RESOLUTION NO. 2020 - 15

A RESOLUTION OF THE LOWER PROVIDENCE TOWNSHIP BOARD OF SUPERVISORS, MONTGOMERY COUNTY, PENNSYLVANIA, APPROVING THE PRELIMINARY/FINAL LAND DEVELOPMENT PLAN OF THE METHACTON SCHOOL DISTRICT FOR ARROWHEAD ELEMENTARY SCHOOL LOCATED ON LEVEL ROAD IN THE TOWNSHIP

Reference: Arrowhead Elementary School – Reconstruction

SUBJECT: **REVIEW COMMENTS – ARROWHEAD ELEMENTARY SCHOOL
PRELIMINARY & FINAL LAND DEVELOPMENT PLAN REVISED JUNE 1, 2020**

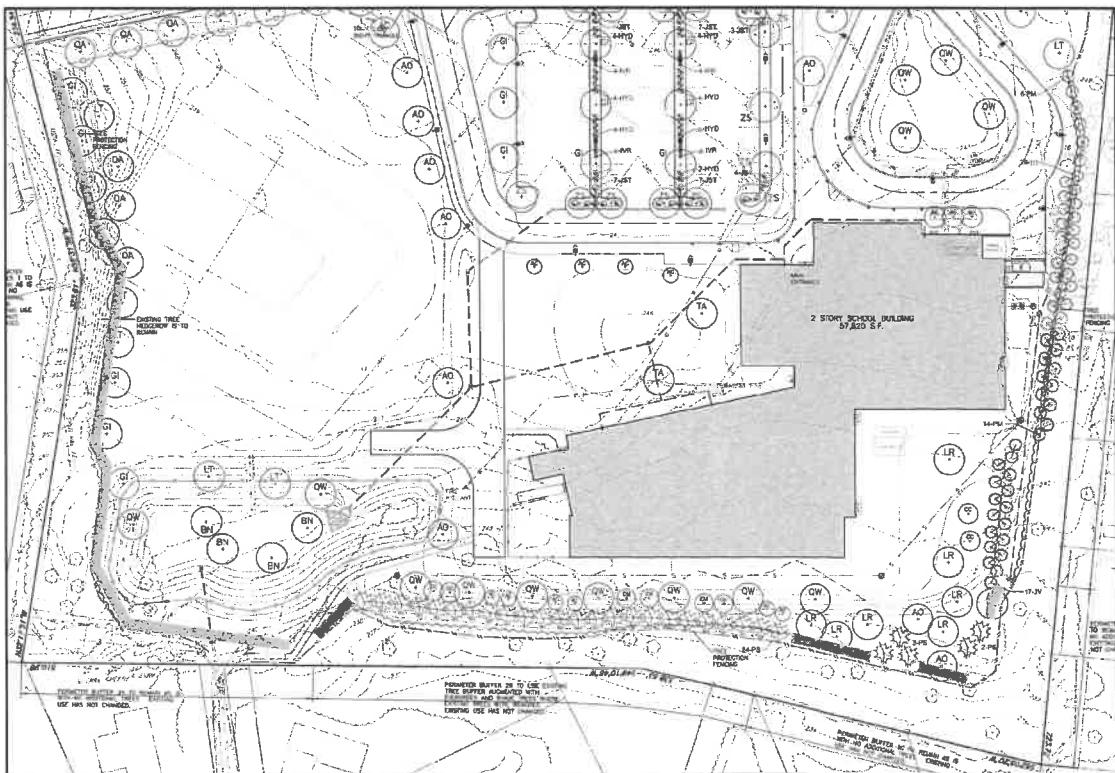
Except for the portion of the school property that abuts the Audubon Water Company property at the northeast (see below comment 3), the remainder of the property abuts single-family residential properties.

Based on our site visit and the type, quantity and condition of the existing vegetation to be preserved along the school property line, we consider the "secondary component" Screening Buffer to be satisfied.

However, in some locations, the "primary component" of evergreen trees is not satisfied by either existing evergreen trees or the proposed planting of new evergreen trees. A Waiver has been requested accordingly. This Waiver would apply along the portions of the property line indicated by a green bar  in the below markup of the 6-1-2020 Landscape Plan:

2.C Primary Component Evergreen Screening: After-Construction Evaluation

The Applicant has requested a Waiver from §123-50.C (SLDO) in order to forgo further Screening Buffer planting. Notably, most of the property boundary where the full evergreen Screening Buffer is not indicated would be along the proposed open play fields and a detention basin where, critically, there will be no adjacent lighting and vehicular traffic. As such, the new proposed "flipped" site layout represents a significant improvement in this respect. In addition, the existing buffering condition along these property boundaries could be considered a type of "existing nonconformity" relative to compliance with the Screening Buffer requirements.

Accordingly, the 6-11-2020 Resubmittal Letter suggests that "an after-construction evaluation can be made to see where additional property line buffers are needed to shield direct sight lines from the adjacent homes."

We believe that this is a reasonable and appropriate approach to ascertaining the need for additional visual buffering along the school property lines adjacent to residences. If determined by the Board of Supervisors to be an appropriate path forward, Conditions of Approval could be prepared accordingly. Conditions could include the following elements:
